Accessibility Survey

City of Downey Laura Street & Old River School Road

Date of Inspection 4/18/2017

Disability Access Consultants

North Crossing @ 33.937883716485, -118.155665695667

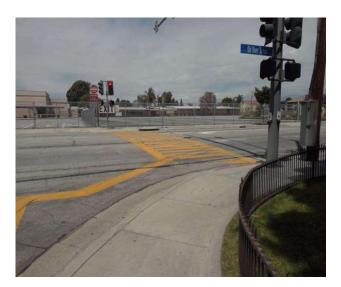
There are no detectable warnings provided for the crosswalk.

On-Site Finding Not Found

Provide compliant detectable warnings for the crosswalk.

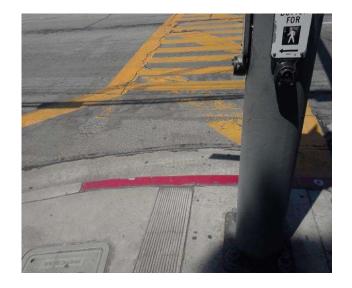
Speech walk message is not provided at the signal.

On-Site Finding Not Found

Provide compliant speech walk message for the signal.

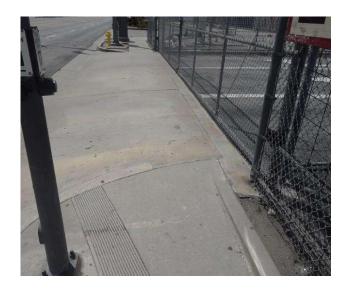
The clear ground space is not level.

On-Site Finding 4.60 percent

Provide compliant level clear ground space at the control.

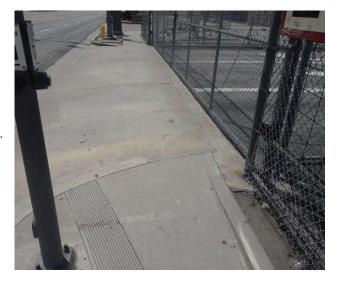
Tactile arrow is either not raised enough or does not contrast with background.

On-Site Finding Not Compliant

Make sure that the tactile arrow is raised at least 1/32 inch and contrasts with background.

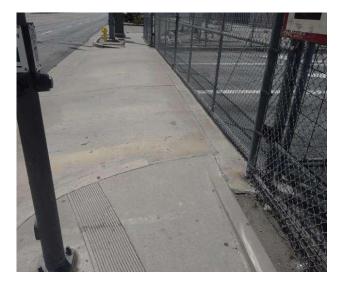
There is no street name information related signage at the signal.

On-Site Finding Not Found

Provide compliant signage that includes street name.

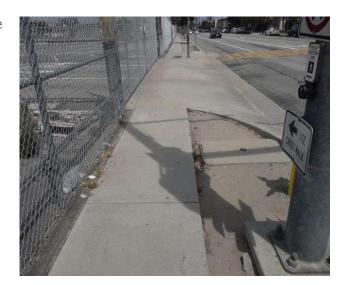
There is not enough clear ground space at the push button.

On-Site Finding 1.00 inches

Provide compliant clear ground space at the push button.

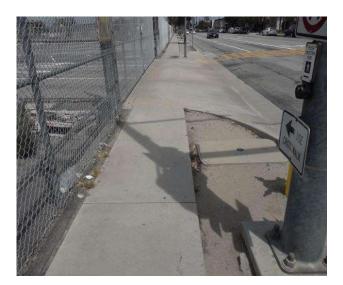
There is not enough clear ground space at the push button.

On-Site Finding 1.00 inches

Provide compliant clear ground space at the push button.

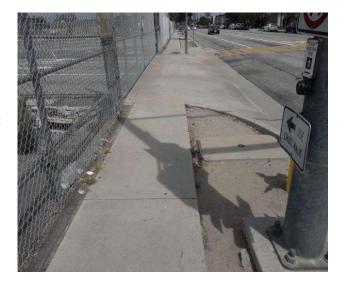
There is no street name information related signage at the signal.

On-Site Finding Not Found

Provide compliant signage that includes street name.

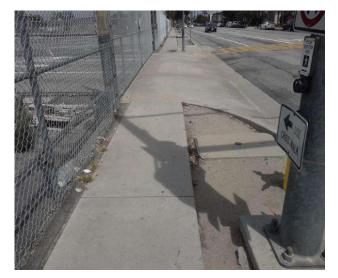
There is no vibro-tactile indication at the signal.

On-Site Finding Not Found

Provide compliant vibro-tactile indicator at the signal.

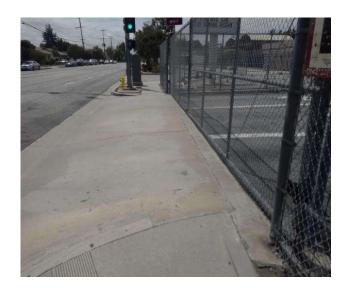
Crosswalk width is not compliant.

On-Site Finding 48.00 inches

Provide a compliant crosswalk for the intersection with recommended width.

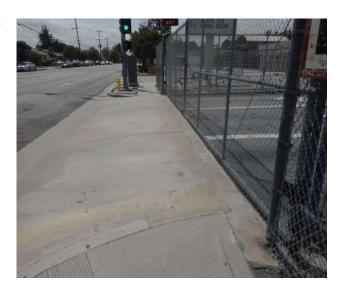
There are no detectable warnings provided for the crosswalk.

On-Site Finding Not Found

Provide compliant detectable warnings for the crosswalk.

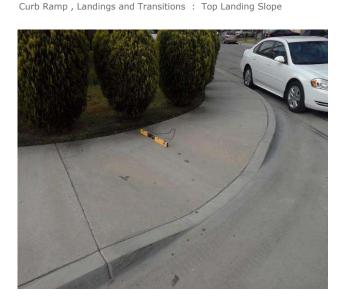
The slope at the top landing is greater than allowed.

On-Site Finding 7.20 percent

Provide a top landing surface that does not exceed the maximum slope and cross slope. Provide a sufficient maneuvering clearance that does not accumulate water.

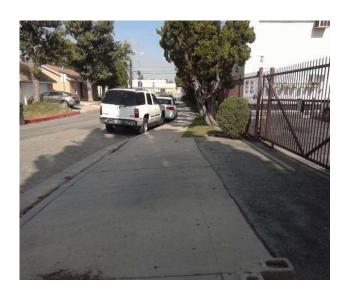
On-Site Finding Not Found

Provide detectable warnings.

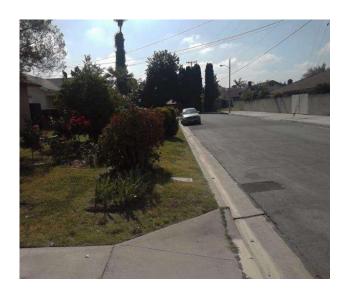
Section of sidewalk is missing and consists of dirt, grass or gravel.

On-Site Finding 135.00 feet

Provide a compliant sidewalk for the missing section.

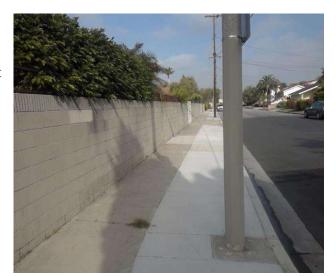
Sidewalk cross slope is not compliant.

On-Site Finding 5.80 percent for 108.00 feet

Repave the sidewalk surface with the recommended cross slope.
